RESPONSE TO COMMENTS

City of Miami Beach,
Wachovia – Alton Road
Response to Building Dept. Cmts.
Page 2 of 4

WACHOVIA - ALTON ROAD BRANCH
1901 ALTON ROAD
MIAMI BEACH, FLORIDA

DESCRIPTION OF WORK:	Construction of New Exterior ADA Ramp; Relocation of ATM & AHD Equipment; Minor Interior Remodel to Create a New ATM Room.
BUILDING CODES:	FLORIDA BUILDING CODE, 2004 EDITION 2004 FLORIDA FIRE PREVENTION CODE NFPA 101, LIFE SAFETY CODE, 2003 EDITION
BUILDING TYPE:	TYPE IIIB
CLASSIFICATION OF WORK:	ALTERATION - LEVEL 2
OCCUPANCY TYPE:	BUSINESS
OVERALL EXISTING BUILDING SQUARE FOOTAGE:	6,085 SF
OCCUPANT LOAD:	1 PERSON/100 S.F. GROSS (6,085 SF/100 SF = 61 PEOPLE)

1 FLOOR PLAN
SCALE: 1/4" = 1'-0"

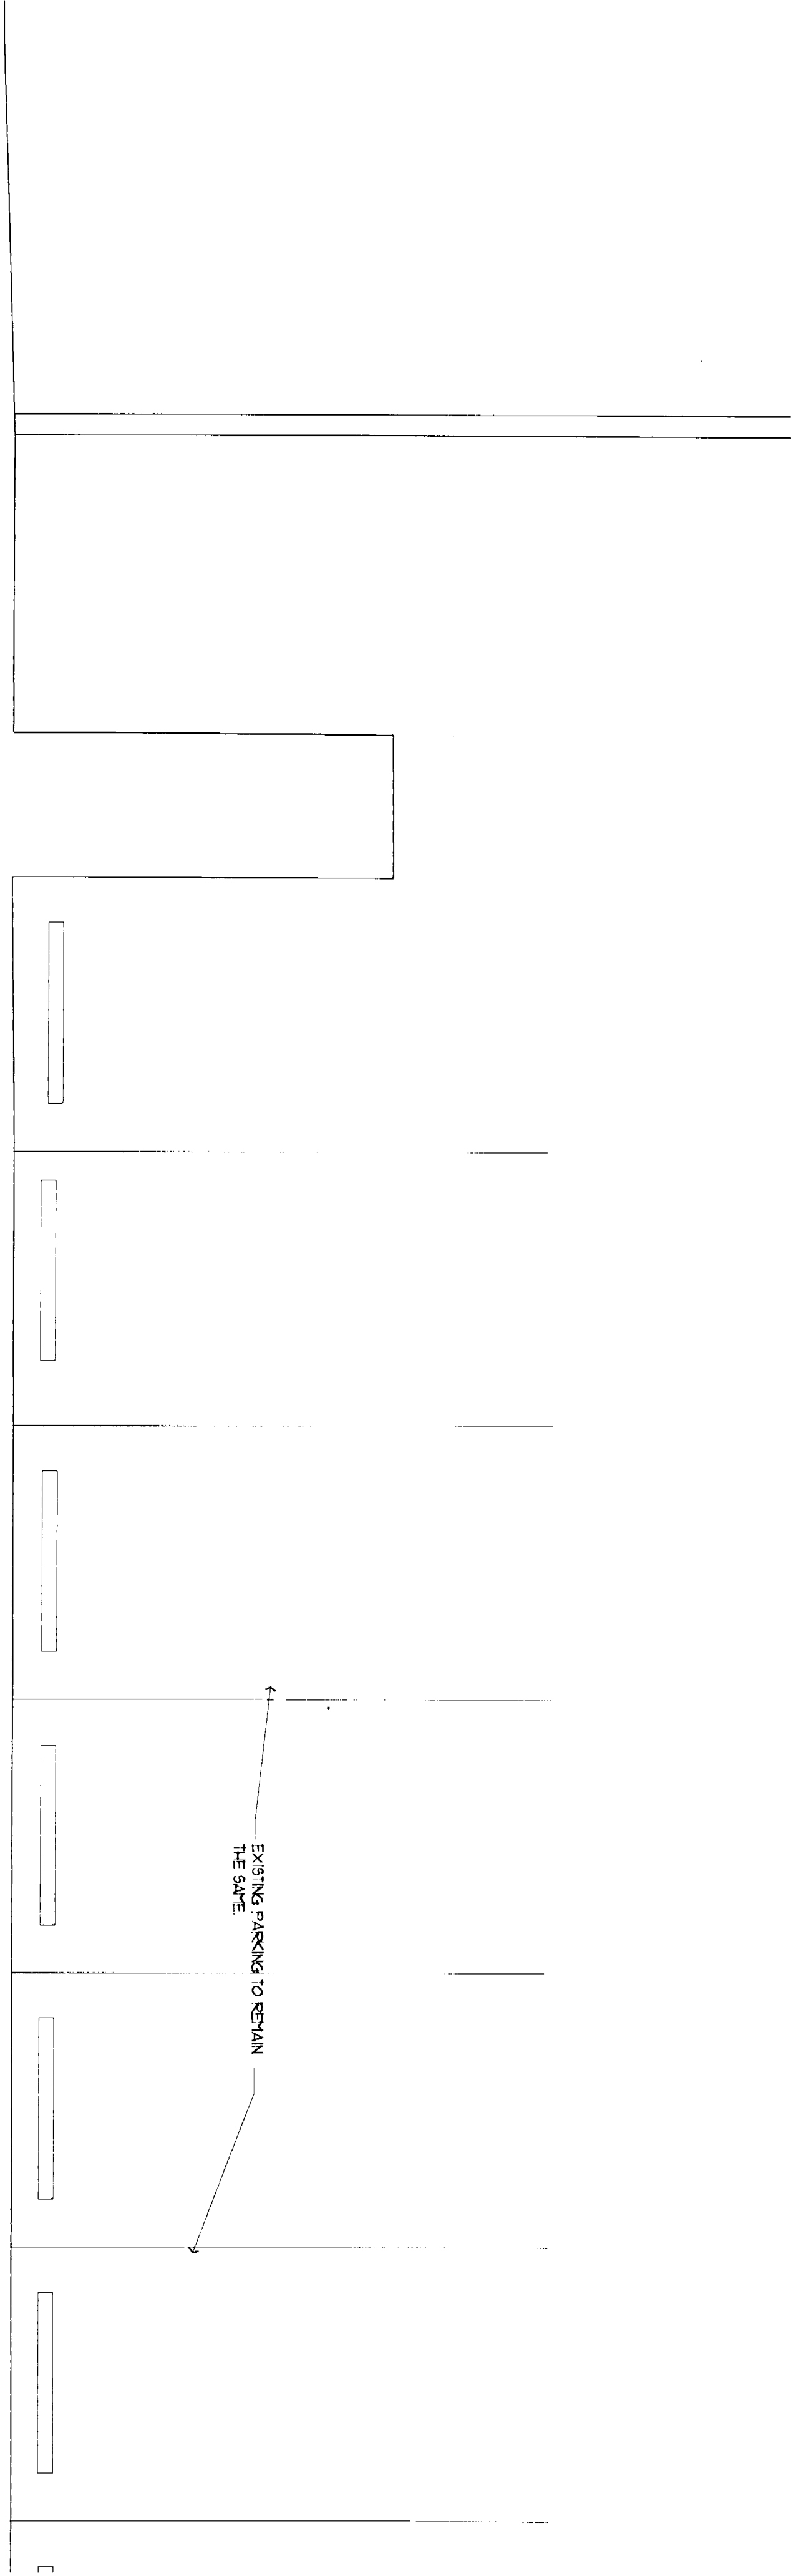
Show and elevation at each surface.

Guards and handrails on both sides shall be provided for ramps. Provide guards and handrail details for ramps.

Provide handrails with their proper extensions along with 3 steps or less need to be 13" min tread with their nosing striped.

Elevation marks have been placed on the Floor Plan. Refer to revised Sheet A1.0 for the information requested.

In accordance with FBC Section 1012.1 and NFPA 7.1.8 guards are required when the open sides exceed 30 inches above the floor or grade below. Please refer to Revised Sheet A1.1 for the applicable grade elevations. The landings and portions of the ramp are, at their maximum, 12" above the grade. Therefore handrails have been provided as opposed to guards.

Refer to Revised Sheet A5.1 and new details 3/A5.1 and 5/A5.1. Section 3/A5.1 indicates the required extensions at the handrails. Section 5/A5.1 calls for stair nosings with an anti-slip abrasive texture and color safety yellow. Refer to Revised Sheet A1.1 for the revised tread dimensions. Treads have been modified to be 13".

1 ELEVATION
2 VERTICAL SECTION / DETAIL

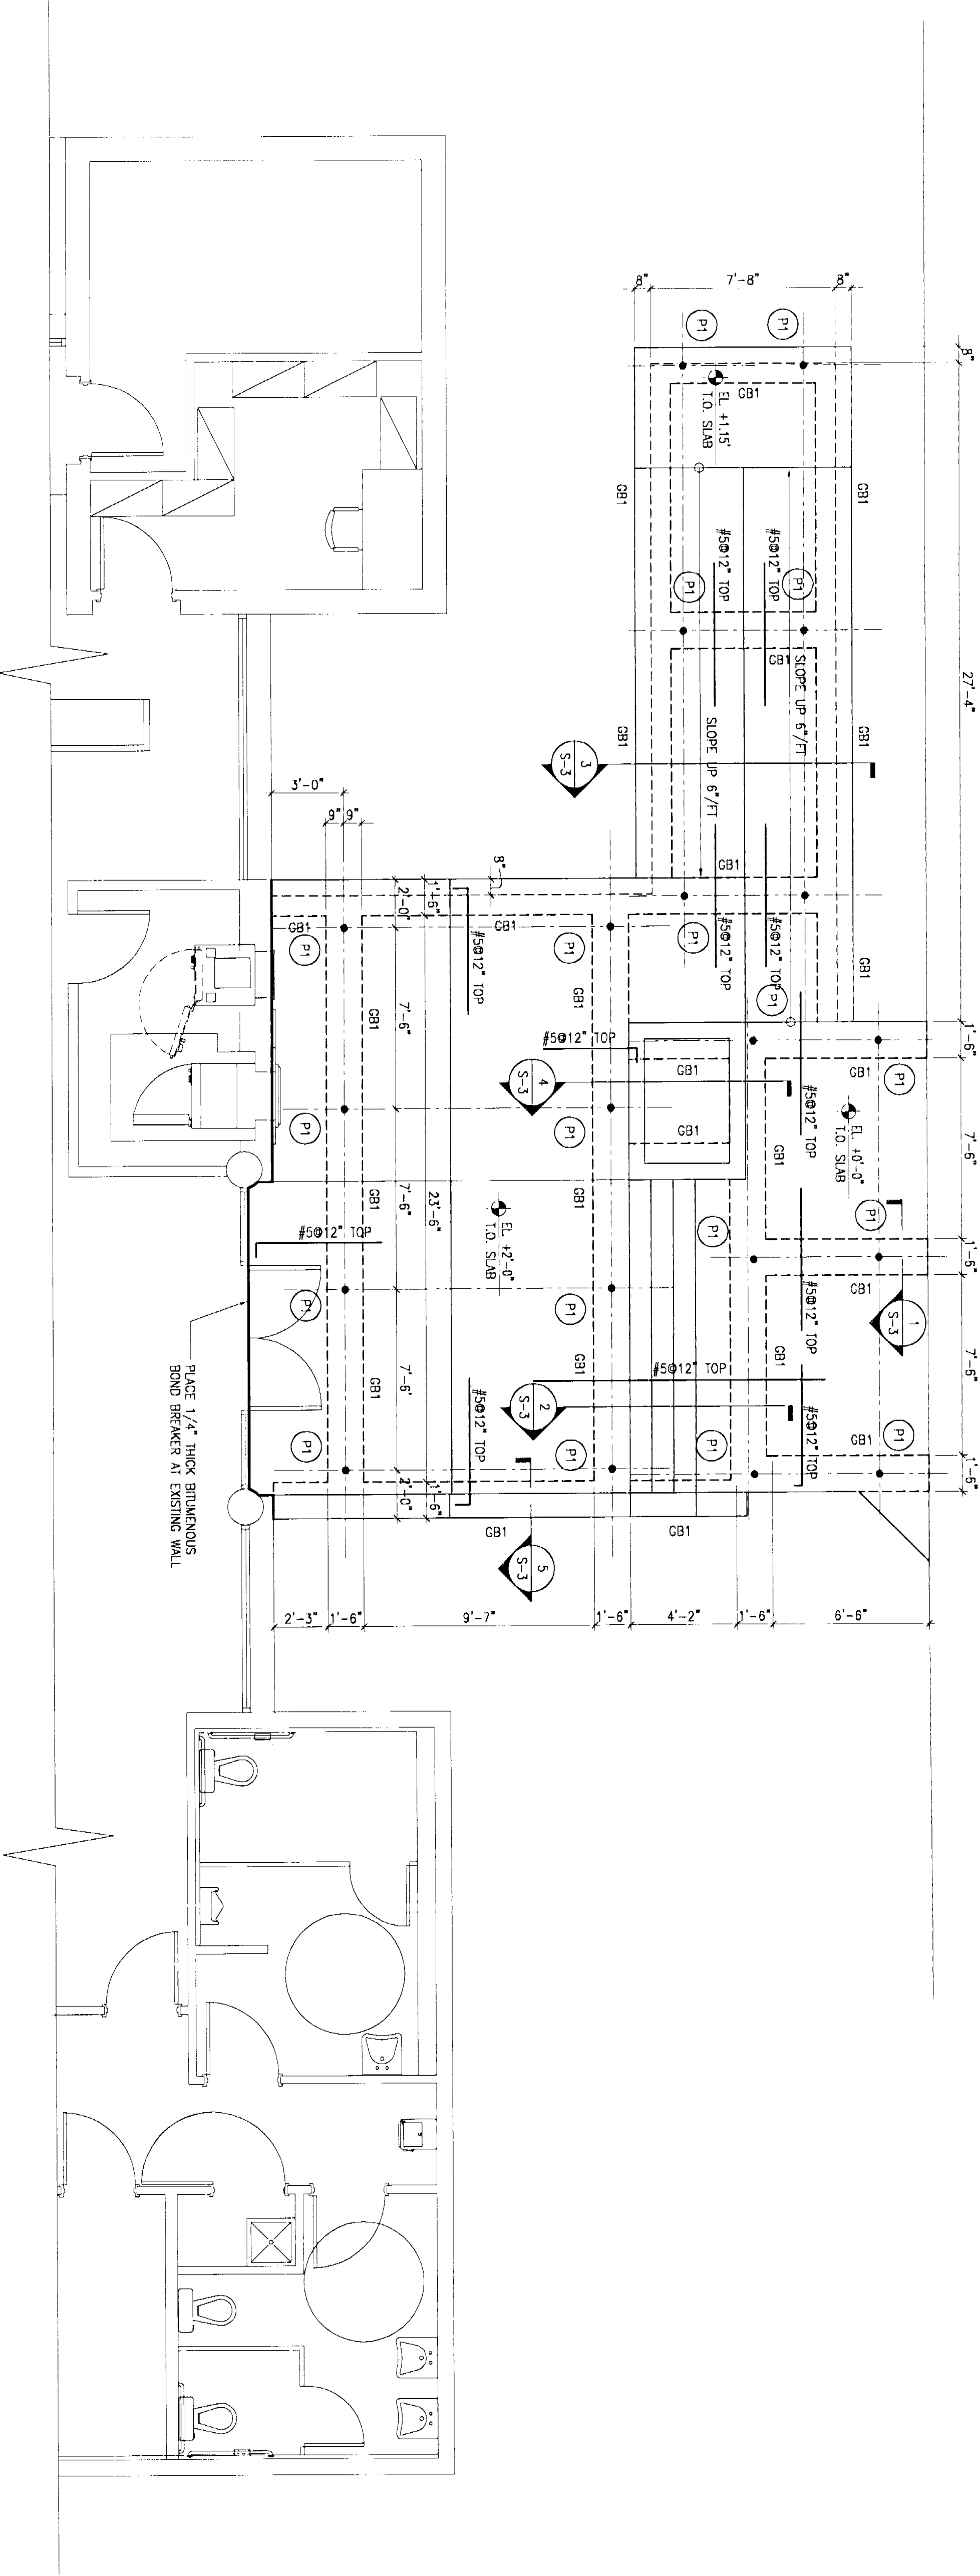
Provide a cross section showing handrail and/or guardrail compliance (FBC 1009.11; FBC 1618) Show a 1-1/2" dimension from top of bracket to bottom of rail.

Show ATM reachable ranges.

Refer to new detail 4/A5.1 on Revised Sheet A5.1. This detail as shown satisfies the requirements of both FBC Chapter 11 requirements and those of the FFPC/NFPA 101 Section 7.2.2.4.4.5. Note also that General Note 5 has been added on Sheet A1.1 for compliance w/ FBC 1618.4.6.

Refer to revised Sheet A5.1 for the elevation of both the ATM and AHD equipment with the applicable heights.

ELECTRICAL SYMBOL LEGEND

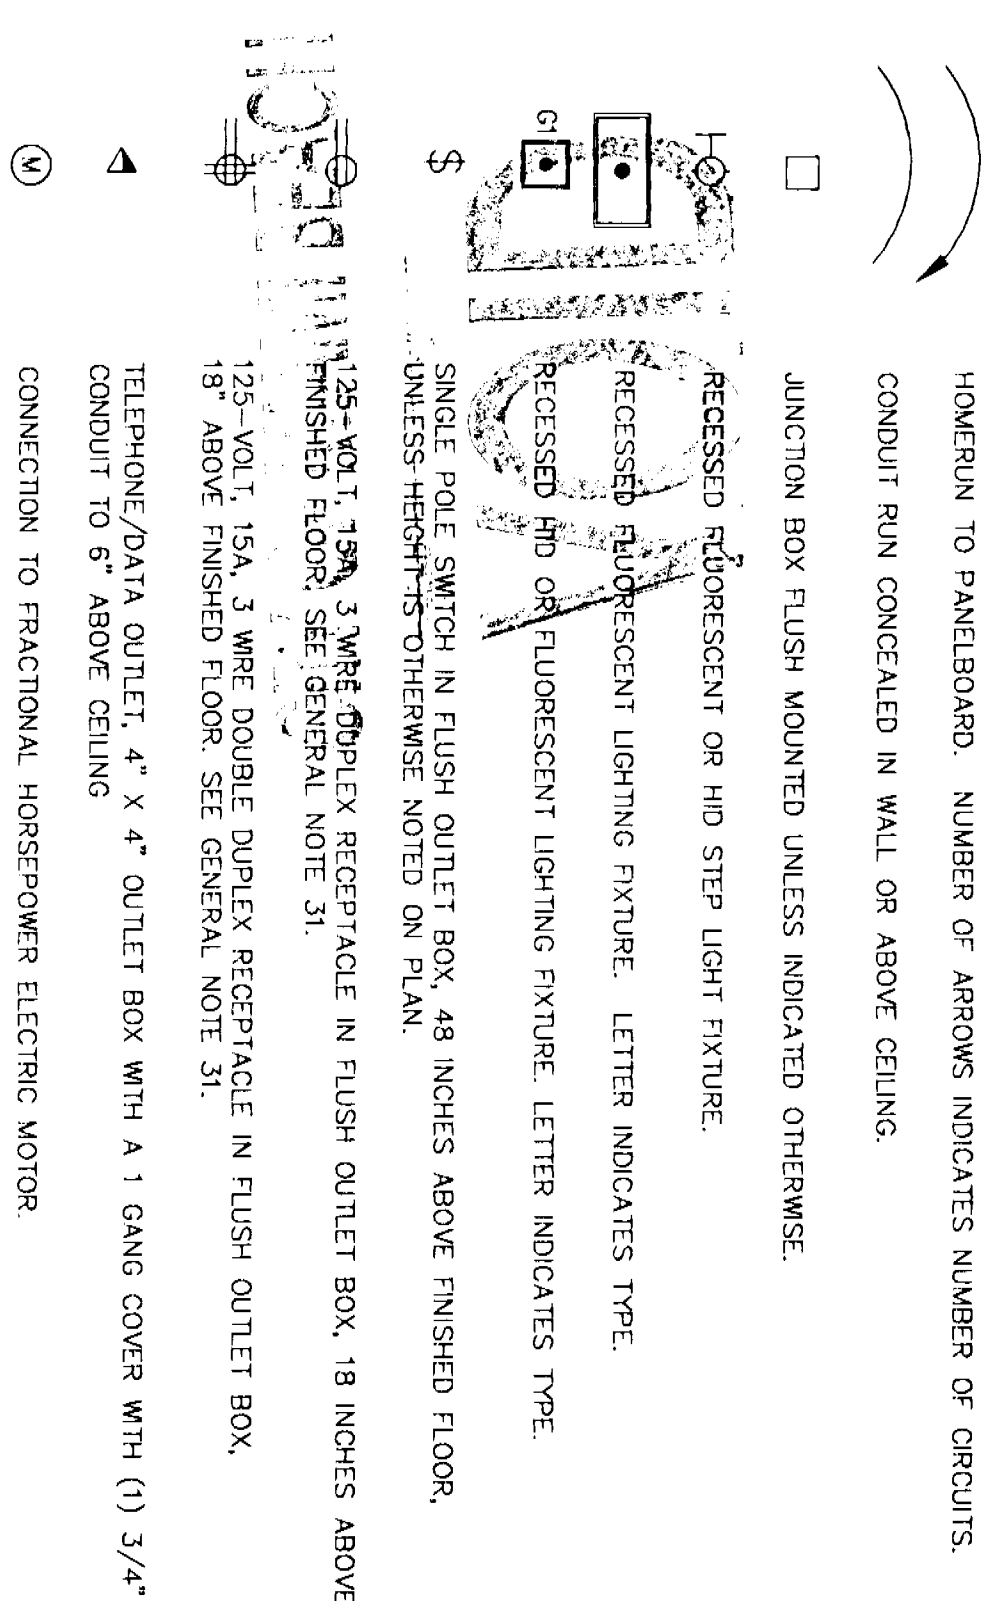
Comment 2: Circuit numbers and existing load on circuits as well as load to be added to circuits.

Comment 4: Fixture Schedule.

Response: The circuit numbers and loads have been added to the drawings. See revised notes on Drawing E0.1, dated Revision 1, 12/12/07. See Revised Floor Plan on Drawing E1.0, dated Revision 1, 12/12/07.

Response: The Lighting Fixture Schedule is shown on Drawing E0.1,
dated Revision 1, 12/12/07.
